UNITED STATES PATENT AND TRADEMARK OFFICE

APPLICATION NO.	FILING DATE	FIRST NAMED INVENTOR	ATTORNEY DOCKET NO.	CONFIRMATION NO.
10/608,671	06/27/2003	Michael J. Pugia	MSA-3452	5201

Office Action Summary

Fig. 3a

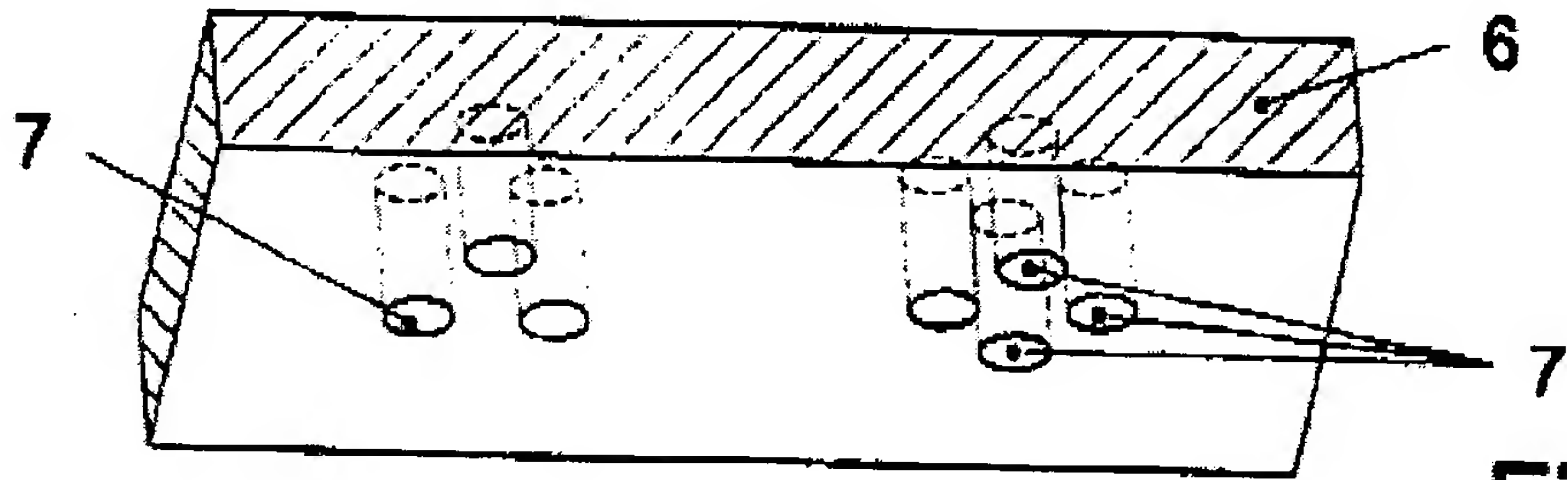
4. Considering objective evidence present in the application indicating obviousness or nonobviousness.
1. Claims 4 – 6 are rejected under 35 U.S.C. 103(a) as being unpatentable over Columbus '029 in view of Peters (U.S. Pat. No. 6,296,126 B1). Regarding claim 4, Columbus '029 is silent to the specific teaching of incorporating wedge-shaped cut-out structures with the microfluidic apparatus. As shown in figure 3b, Peters does teach the incorporation of wedge-shaped cut-out structures (columnar projection 9 having wedge-shaped cut-outs 1) within a microfluidic apparatus for facilitating effective fluid control within a microfluidic device (see col. 1, line 10 – col. 6, line 67; figures 1a, 3b & 4).

Fig. 3b

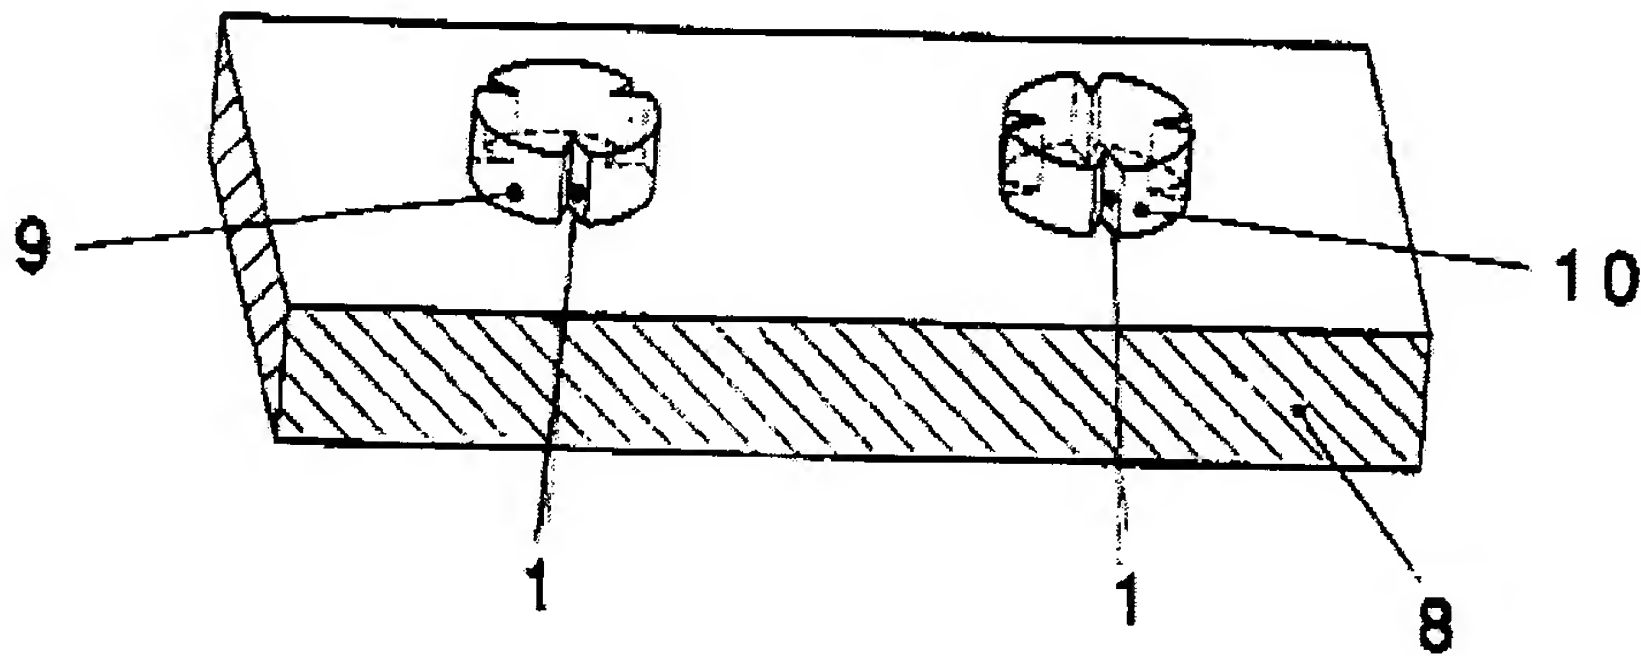
Regarding claims 5 and 6, as shown in figure 3b, these cylindrical or columnar projections (9) comprise essentially post structures, which extend from the base-plate (8), having wedge-shaped cut-outs (1) (see col. 5, lines 1 – 15).
